County of Bernalillo State of New Mexico

From: Julie Luna, Bernalillo County Transportation Planner

Subject: Avanzando Draft Traffic Impact Study

Below are Bernalillo County comments on the subject draft TIS dated March 18, 2022. Please address these comments for the subsequent submittal.

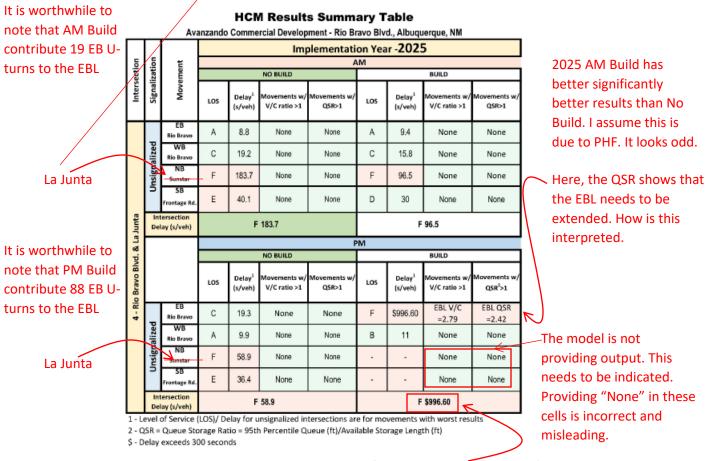
12. Page 18, A-80 Rio Bravo & Sunstar – There appears to be minor typos on Page 18 Summary Table in 2025 PM No Build. I think it is worthwhile to include in this section's narrative the increase in the number of the EBU for Build scenario. I feel like it is worthwhile to include the number of U-turn generated by the site. There is a discussion that the limited access generates the need for U-turns this could be a good place to put the number of U-turns (15 AMPH, 70 PMPH).

Intersection #4 - Rio Bravo Blvd. / La Junta Rd. - Appendix Pages A-85 thru A-93

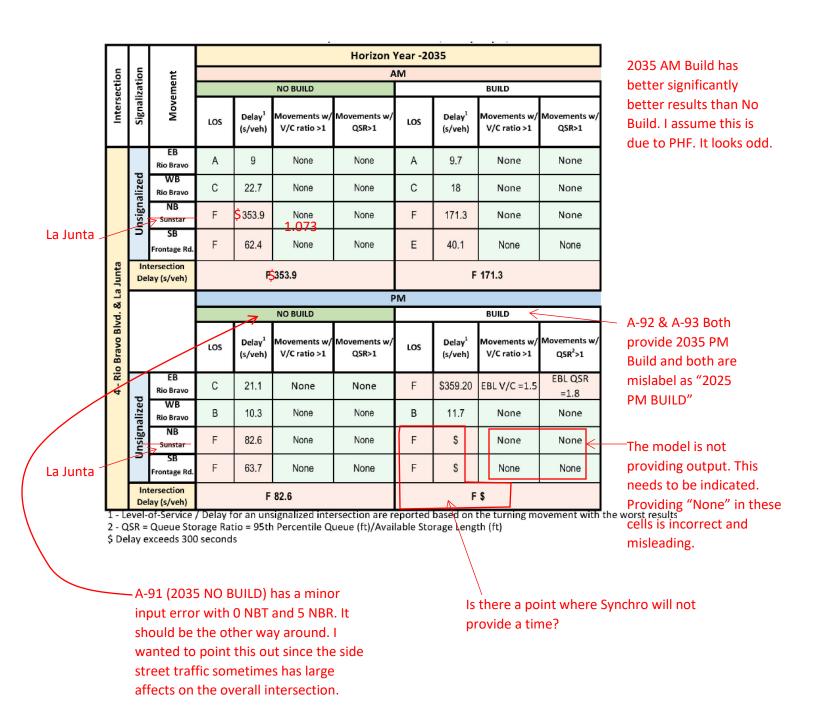
I assume that model output over 300 seconds of delay is beyond the model's capabilities. I really appreciate seeing that the model says it will take over 16 min to make an EBL, but it needs to be noted if results over 300s may not carry the same validity as results below 300s delay.
